## ADDENDUM TO THE CONTRACT

### AURORA HARBOR REBUILD, PHASE III Contract No. DH23-015

**ADDENDUM NO.:** ONE

**March 6, 2023**

**E11**

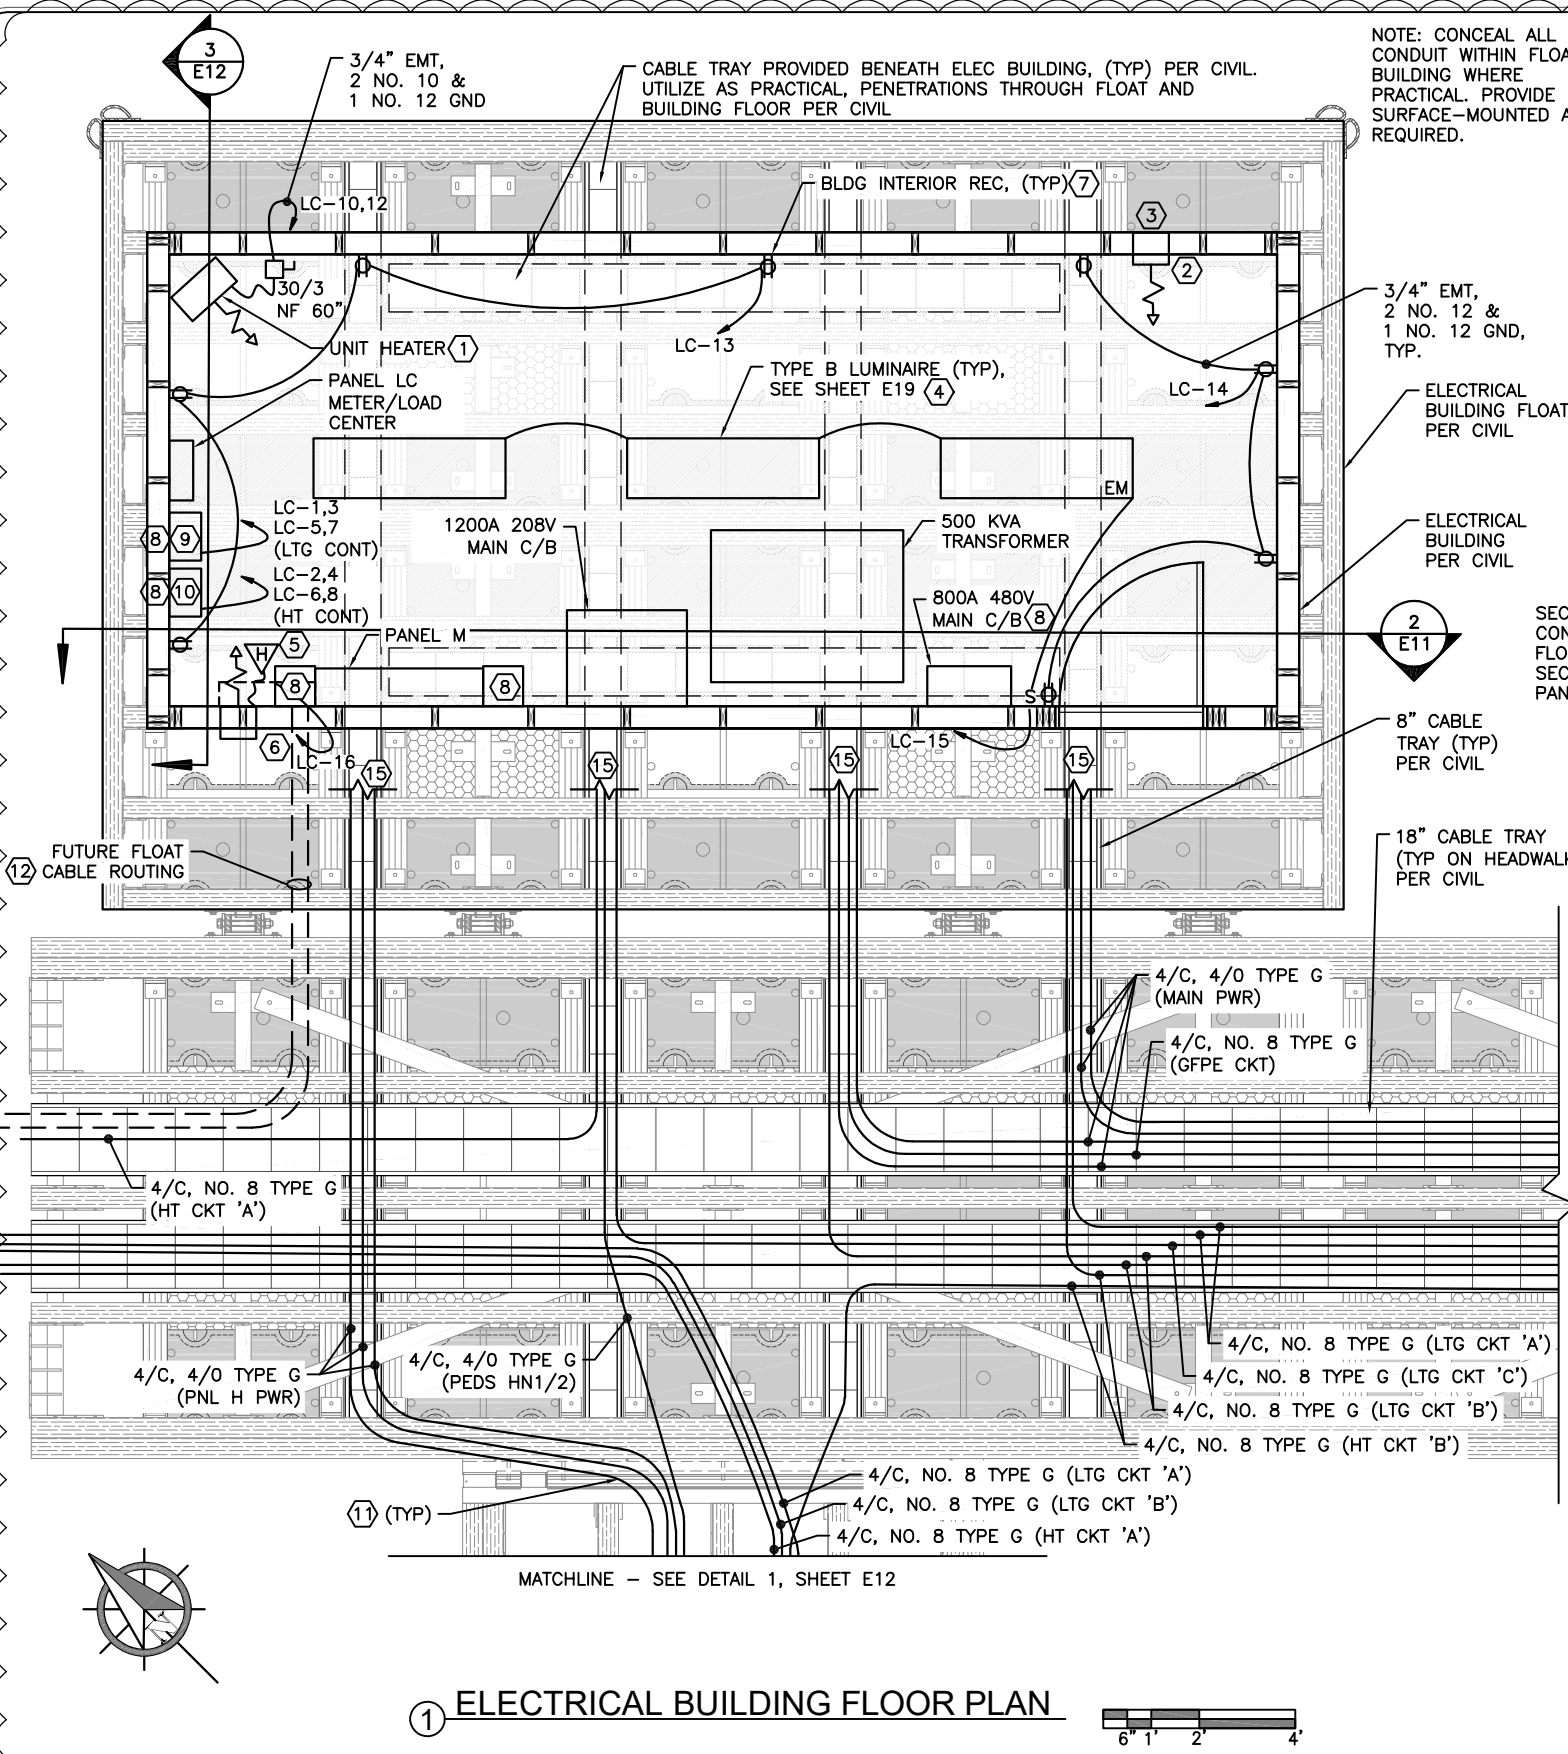
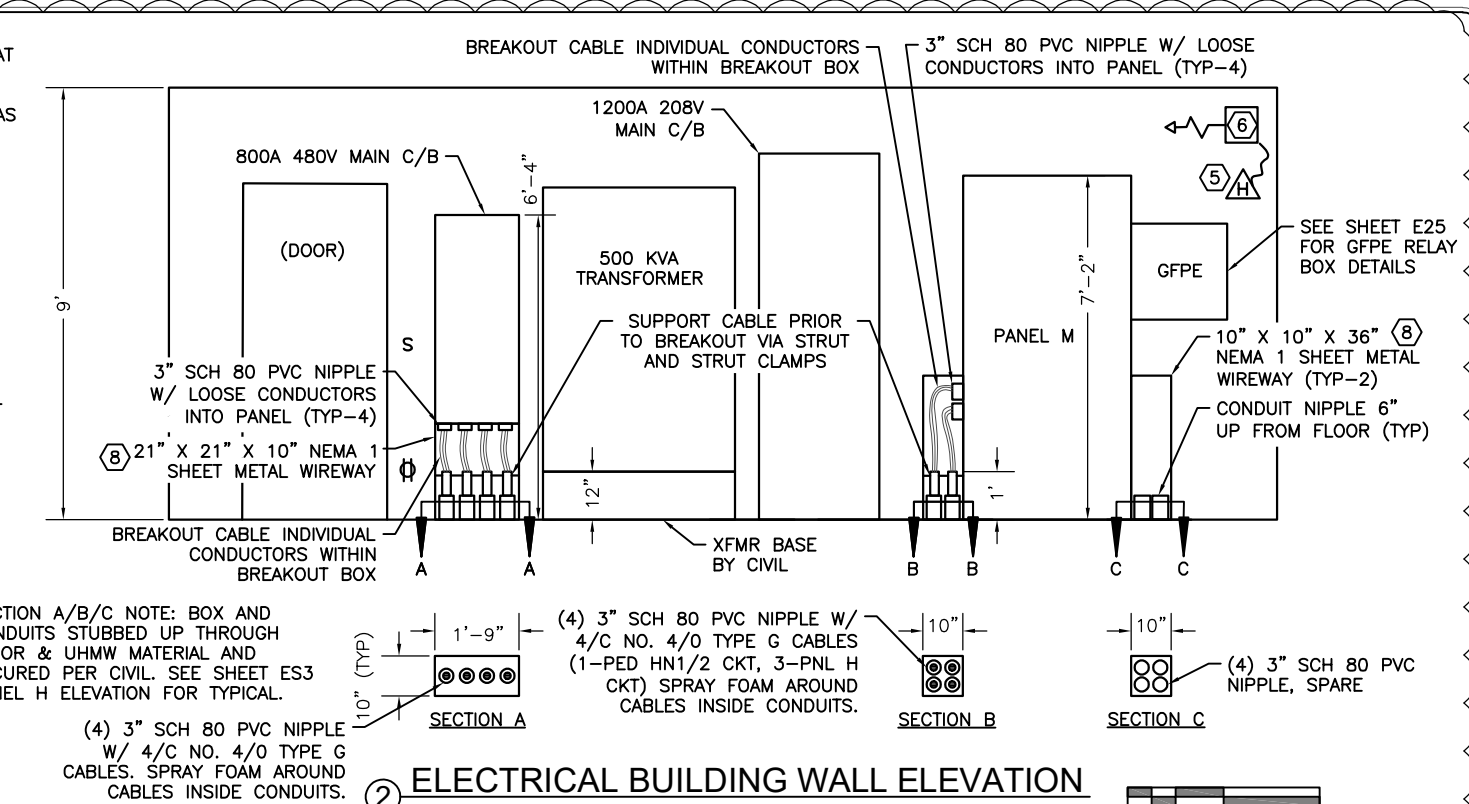
Item No. 30 SHEET E11, ELECTRICAL BUILDING FLOOR PLAN & CABLE ROUTING, **Replace** existing sheet with attached SHEET E11 labeled Addendum 1.

- 14 CONTRACTOR RESPONSIBLE FOR PROVIDING AND COORDINATING STRUCTURAL ELEMENTS ASSOCIATED WITH FLOAT MOUNTED ELECTRICAL. SEE GENERAL NOTE 32 ON SHEET E1 FOR MORE INFORMATION.

Y:\113\_CBJ\41\_aurora harbor phase iii\working drawings\E18 PEDESTAL WIRING DIAGRAMS 3/3/2023 10:23 AM

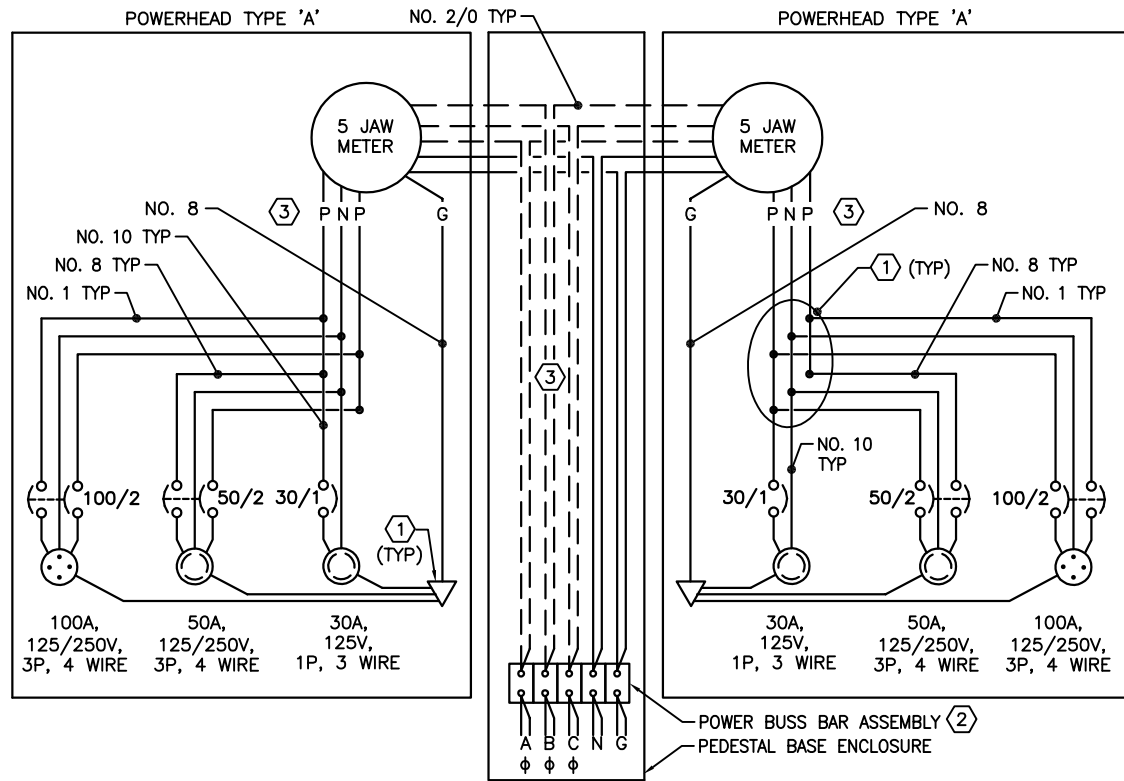
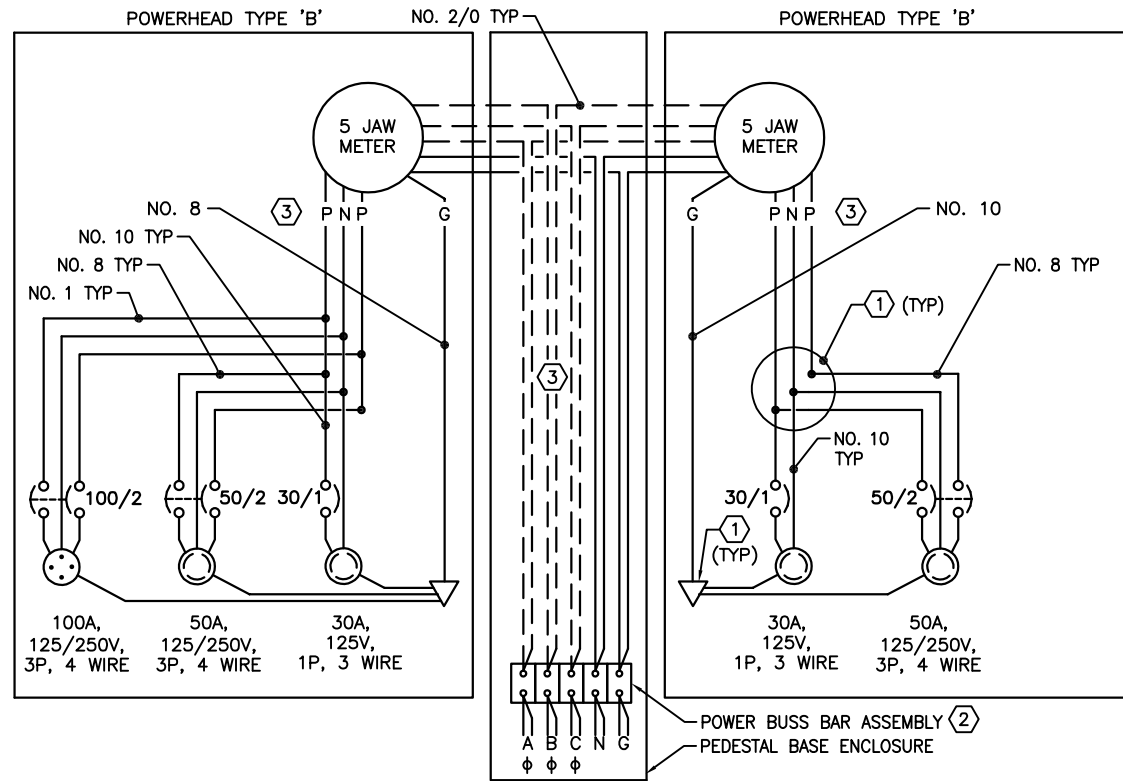
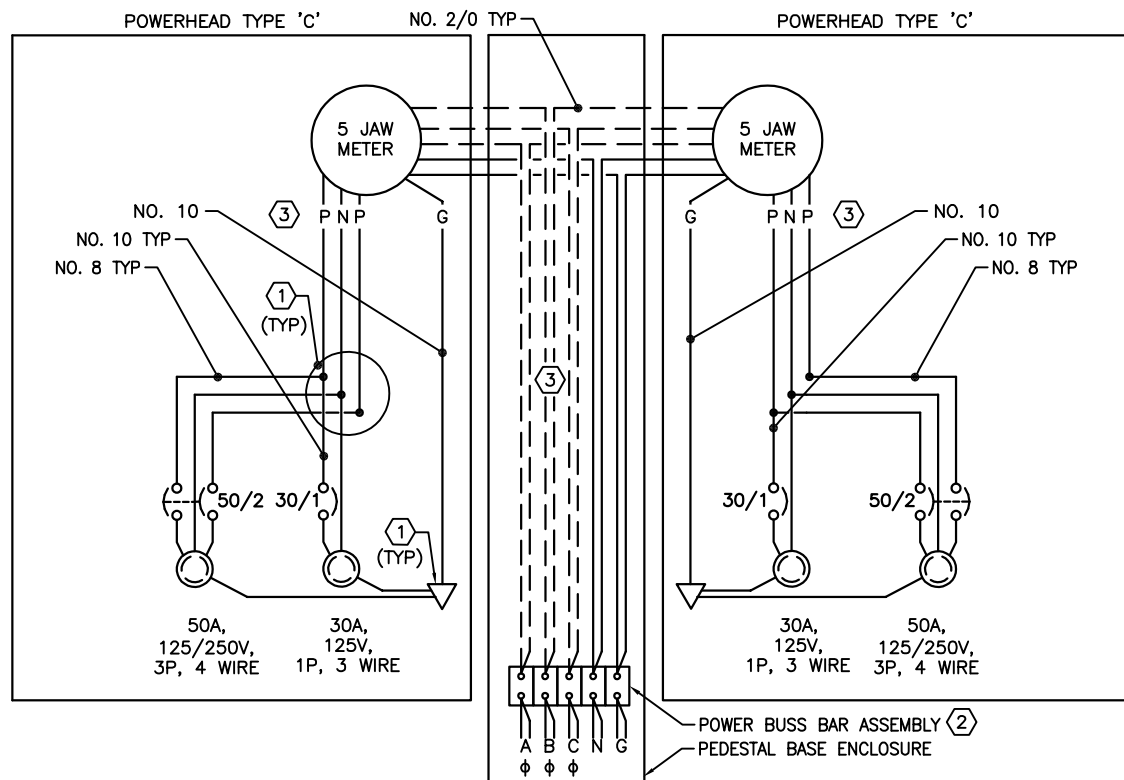
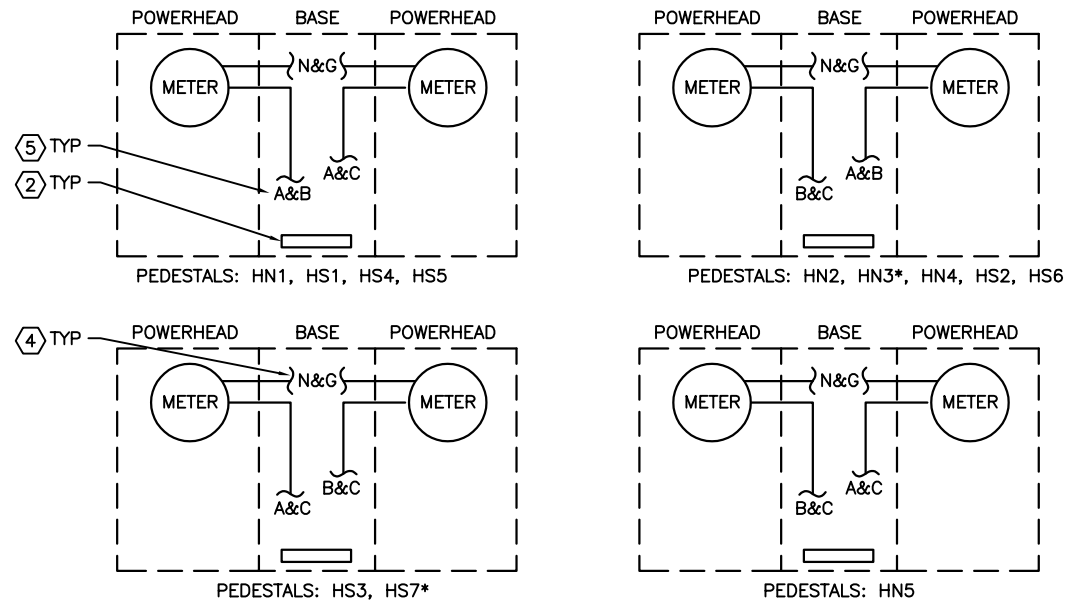
- Item No. 36 SHEET E18, PEDESTAL WIRING DIAGRAMS, **Replace** existing sheet with attached SHEET E18 labeled Addendum 1.
- Item No. 37 SHEET E21, HEAT TRACE JUNCTION BOX DETAIL, **Add** the following general note:
